HISTORIC AND DESIGN REVIEW COMMISSION

HDRC CASE NO: 2018-166
ADDRESS: 316 E MYRTLE
LEGAL DESCRIPTION: NCB 1751 BLK 6 LOT 5
ZONING: MF-33, H
CITY COUNCIL DIST.: 1
DISTRICT: Tobin Hill Historic District
APPLICANT: Randall Mersch
OWNER: Randall Mersch
TYPE OF WORK: Replace aluminum windows with vinyl windows to match remaining vinyl windows
APPLICATION RECEIVED: March 29, 2018
60-DAY REVIEW: May 28, 2018
REQUEST:

The applicant is requesting a Certificate of Appropriateness for approval to replace (6) aluminum windows with vinyl windows to match remaining (7) vinyl windows.

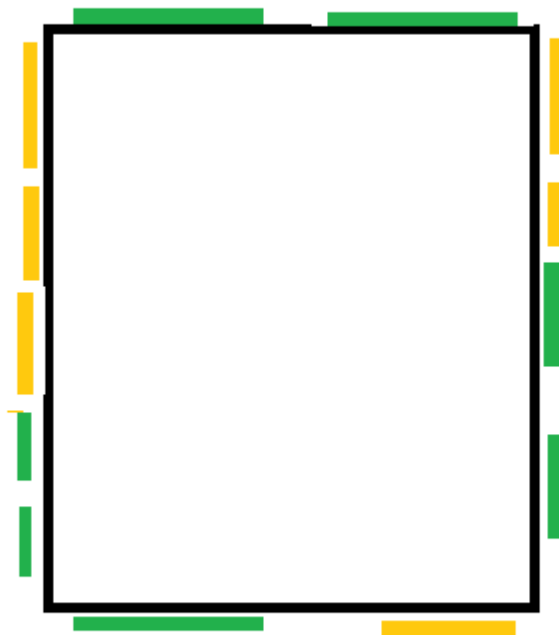
Good

Needs to be Replaced
